寄件者: Vivian Wai [REDACTED]
寄件日期: 2026年08月12日星期三 15:03
收件者: tpbpd/PLAND
副本: Andrea Wing Yin YAN/PLAND; Ivan Sze Yuet FUNG/PLAND; Athena Pui Yin LAI/PLAND; Yen PY LEUNG/PLAND
主旨: S. 16 Planning Application No. A/YL-KTN/1254 - Departmental Comments
附件: LD-L1047A-BP01.pdf; KTN1254_回應部門意見(10Aug2026)古蹟辦.pdf; KTN1254_回應部門意見(10Aug2026)漁護署.pdf; LD-L1047A-DS01A (Report).pdf

Ref. S. 16 Planning Application No. A/YL-KTN/1254 - Departmental Comments

Stormwater Drainage Design

Report No.: **LD/L1047A/DS01A**
Date: **11/8/2026**

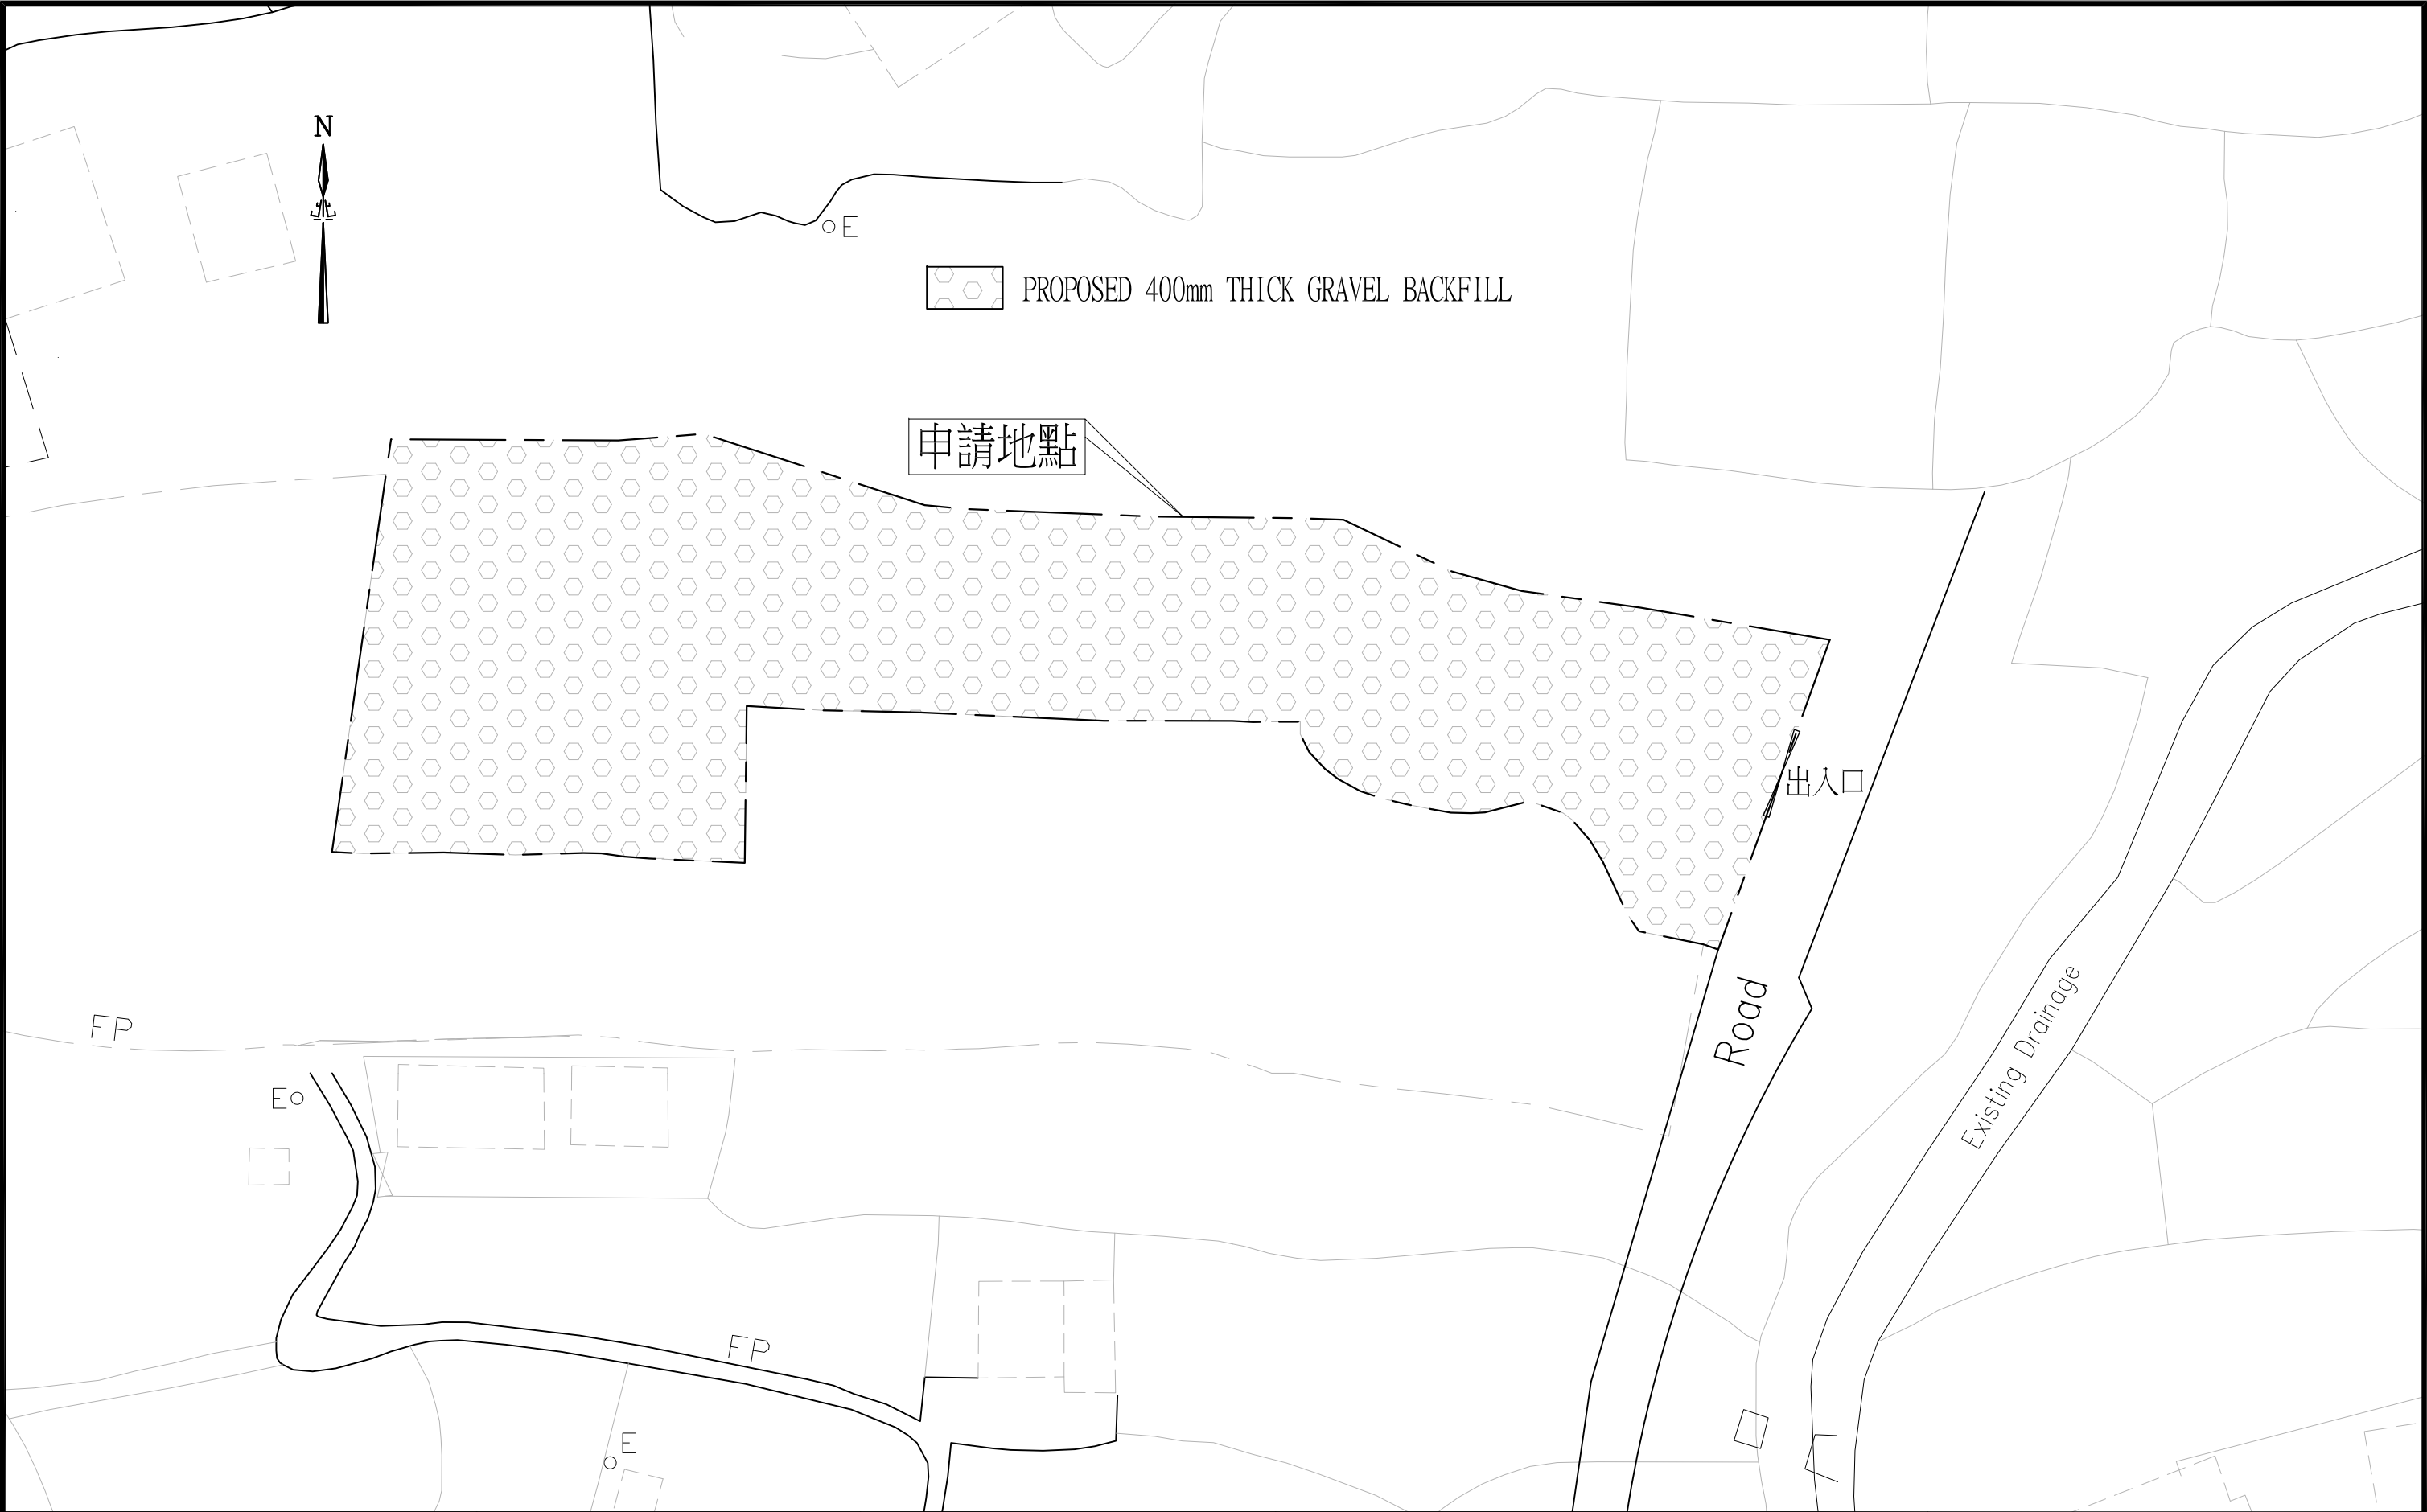
The application site ("the Site") falls within Tai Kong Po Site of Archaeological Interest (SAI). According to the submission, ground excavation for catchpits and 300-375mm u-channels will be carried out along the site periphery. According to the previous archaeological works at the Site, archaeological remains from Song, Ming and Qing dynasties were unearthed underneath a shallow topsoil about 10-15 cm thick.

Considering the archaeological significance of the SAI and the presence of findings immediately under ground level, AMO has concerns on the possible impact from the proposed works on the SAI. The applicant is advised to explore no further excavation (including but not limited to site formation works, drainage works, sewerage works, construction of septic tank, etc.) when carrying out the proposed development at the Site. If excavation is found unavoidable, the applicant is required to conduct an Archaeological Impact Assessment (AIA), which includes a baseline review and field investigation, to evaluate the archaeological impact to be imposed by the proposed development and its associated works. Should the AIA involve fieldwork and excavation, the applicant shall engage an archaeologist to apply for a licence under the Antiquities and Monuments Ordinance, Cap. 53. An Archaeological Action Plan shall be submitted to AMO for agreement before the licence application. Subject to the findings of the AIA, appropriate mitigation measures, if needed, shall be recommended for agreement by AMO and implemented by the applicant to the satisfaction of AMO.

在考慮考古遺址造成的影響而言，在進行該地塊的擬建開發項目時，不會進行任何進一步的開挖工程，亦沒有污水工程及化糞池建造等。申請場地內排水工程內的 300 至 375 毫米 U 型溝渠和集水坑，是會以 U 型預製件，完全取消向下挖掘的地面開挖工程，改為在地面上置放式混凝土明渠。

1. 工程首先是會在現有地面上加固防護，先在表土上方鋪設一層地質織物 (Geotextile) 或細沙，作為保護層，以作為地面物理隔離與緩衝，防止上層填料與原生表土混合。在原土地上方進行輕量化施工，透過取消地下開挖並全面改為地面輕量化施工，能大幅降低對潛在考古遺址的破壞。
2. 本項目僅為「臨時」用途，改為在地面上置放式混凝土明渠是具備完全還原，由於所有設施（預製明渠、以地面鋪墊方式及地質織物）均為地面置放，當臨

時牌照期滿或停止營運時，所有物料均可完全移除，地面能輕易恢復原貌，絕不對地下潛在的考古遺存留下永久性破壞。

3. 申請場地並無污水處理工程及化糞池的建設，不存在化糞池的滲漏、沒有深挖及地下管網，對考古遺址沒有造成二次生環境與物理破壞風險。
4. 在涉及只存放車輛的考量中，申請人會以分散荷載方式，在細沙/地質織物上方，鋪設足夠厚度的碎石層、預製混凝土板或臨時鋼板，以作為申請場地內的行車車路，能有效分散車輛的集中荷載，避免點受壓過大導致地下地層變形。
5. 申請人承諾以上技術細節，以消除可能產生的物理性重壓是否會擠壓或破壞地下遺蹟的疑慮。

現附上新圖及排水報告

(1)排水建議圖

(2)填土位置圖

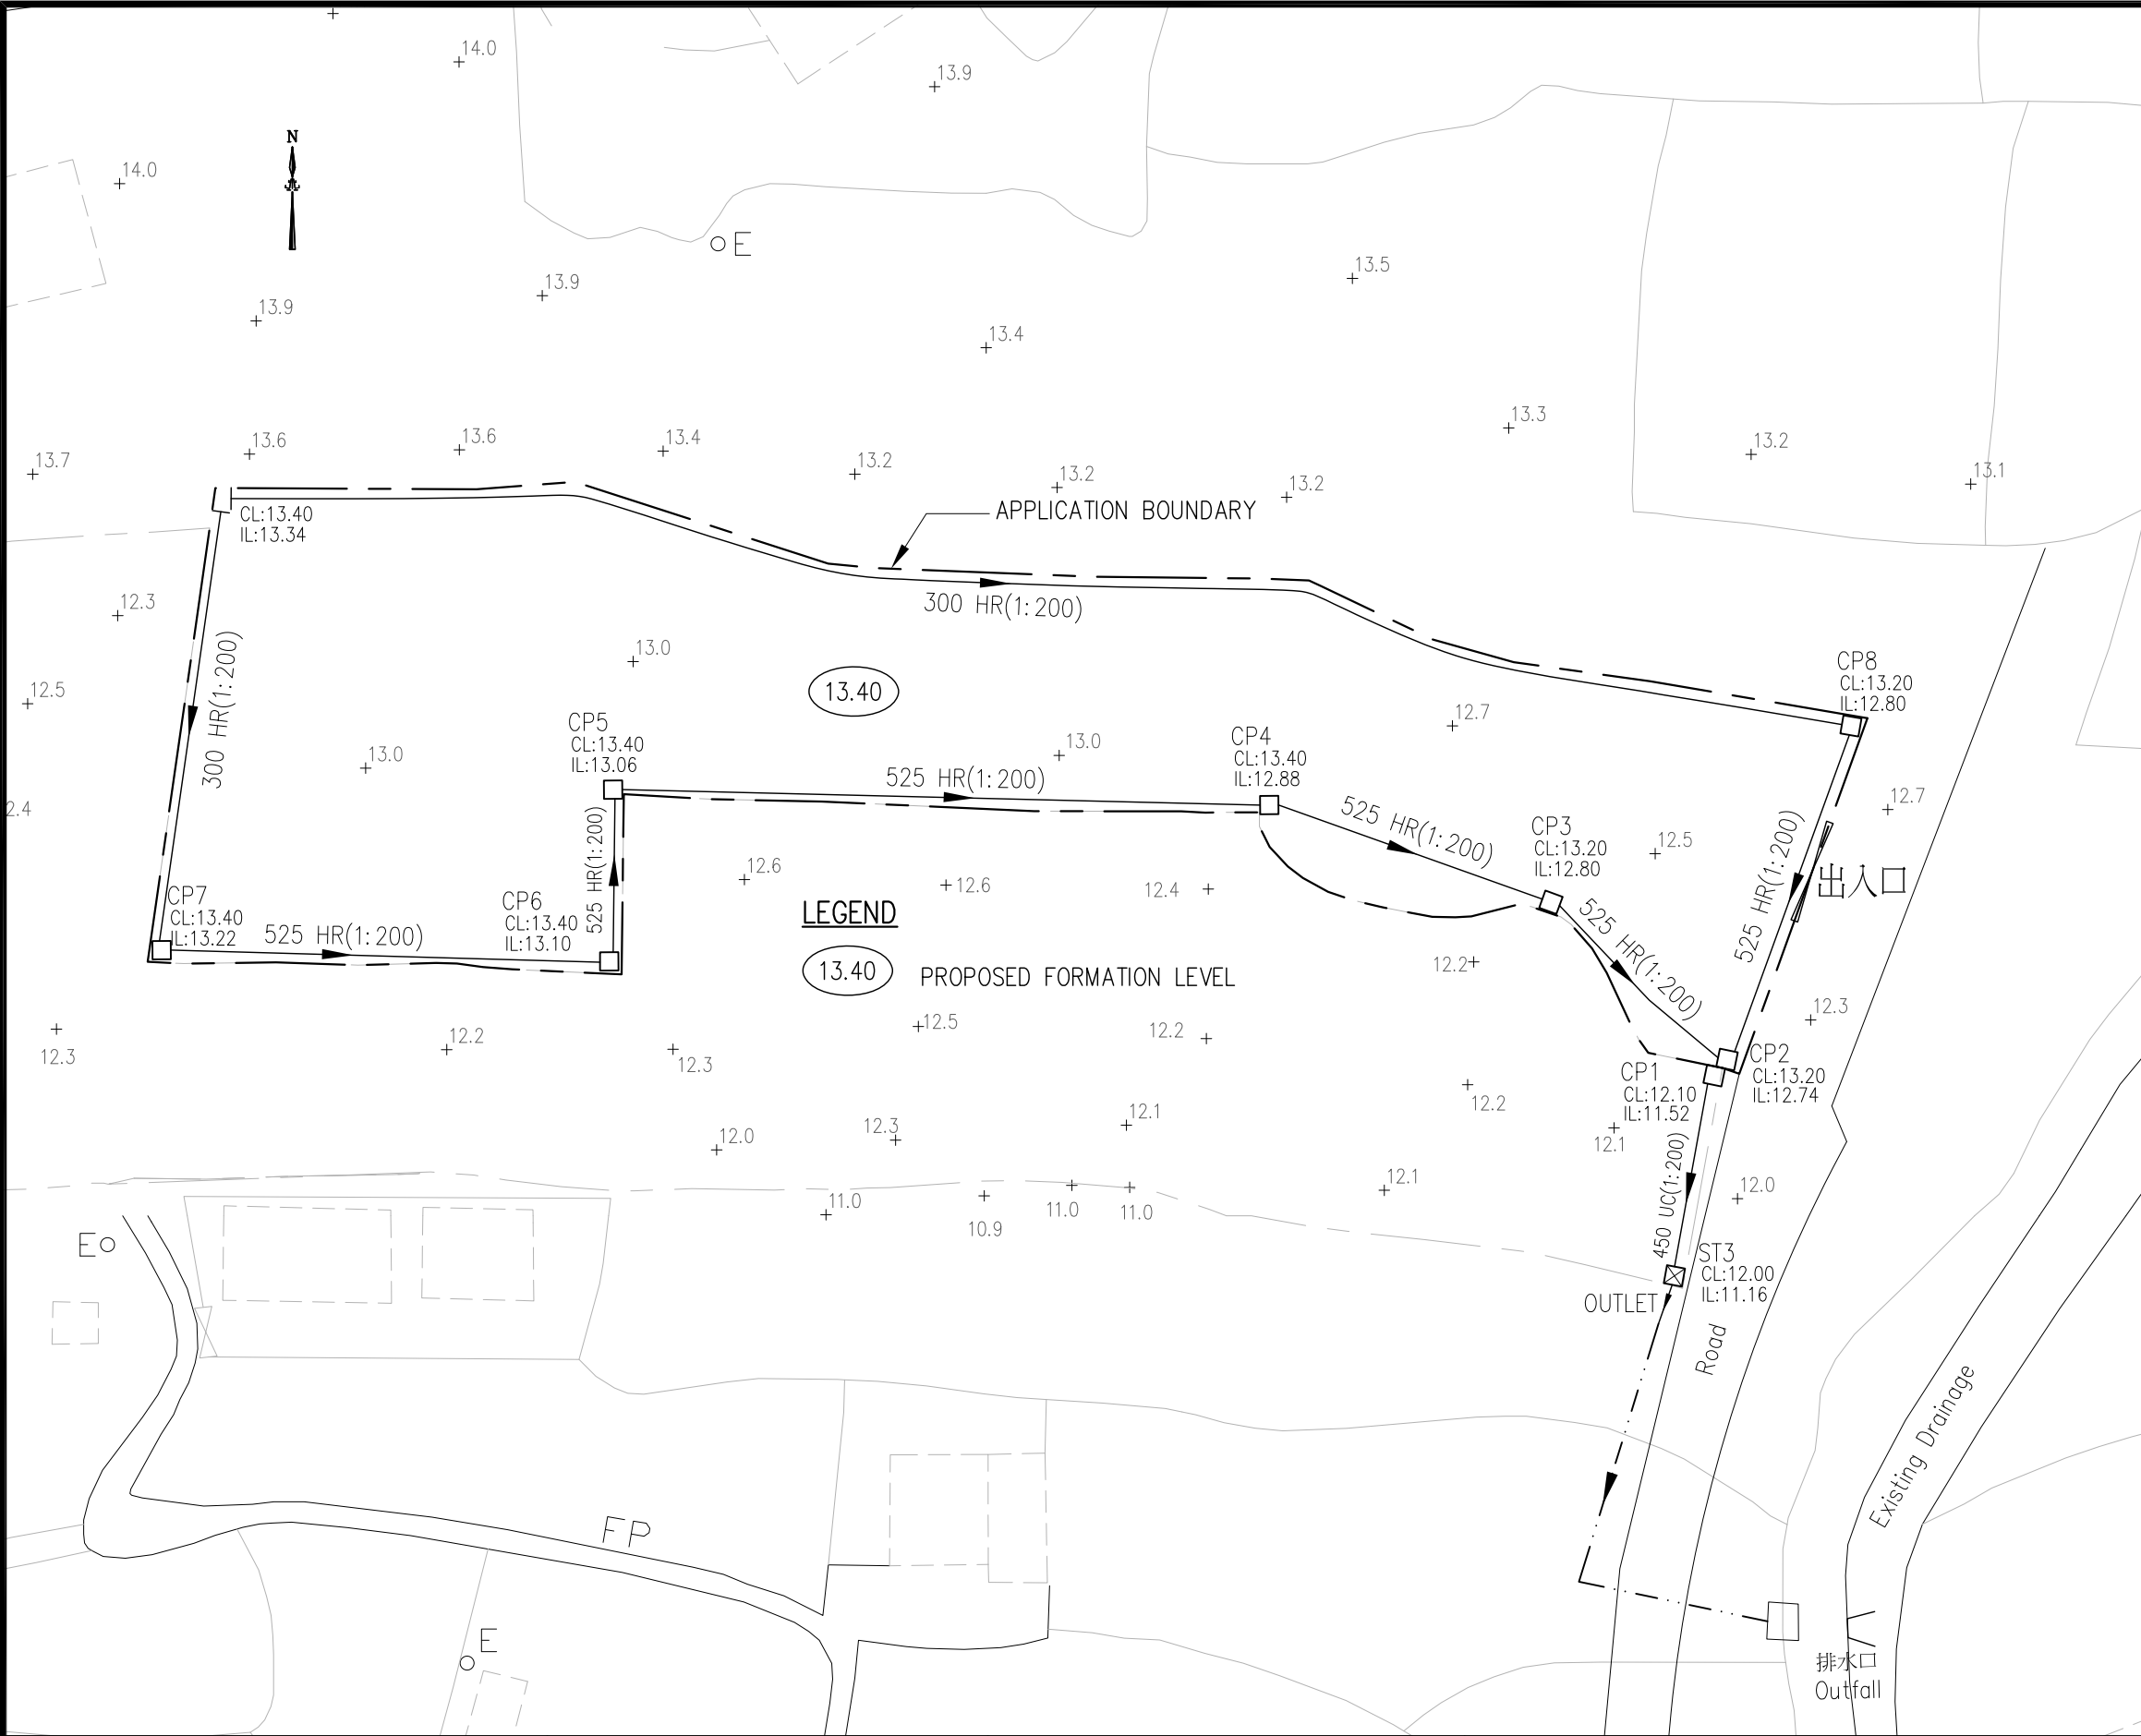
The application site ("the Site") falls within Tai Kong Po Site of Archaeological Interest (SAI). According to the submission, ground excavation for catchpits and 300-375mm u-channels will be carried out along the site periphery. According to the previous archaeological works at the Site, archaeological remains from Song, Ming and Qing dynasties were unearthed underneath a shallow topsoil about 10-15 cm thick.

Considering the archaeological significance of the SAI and the presence of findings immediately under ground level, AMO has concerns on the possible impact from the proposed works on the SAI. The applicant is advised to explore no further excavation (including but not limited to site formation works, drainage works, sewerage works, construction of septic tank, etc.) when carrying out the proposed development at the Site. If excavation is found unavoidable, the applicant is required to conduct an Archaeological Impact Assessment (AIA), which includes a baseline review and field investigation, to evaluate the archaeological impact to be imposed by the proposed development and its associated works. Should the AIA involve fieldwork and excavation, the applicant shall engage an archaeologist to apply for a licence under the Antiquities and Monuments Ordinance, Cap. 53. An Archaeological Action Plan shall be submitted to AMO for agreement before the licence application. Subject to the findings of the AIA, appropriate mitigation measures, if needed, shall be recommended for agreement by AMO and implemented by the applicant to the satisfaction of AMO.
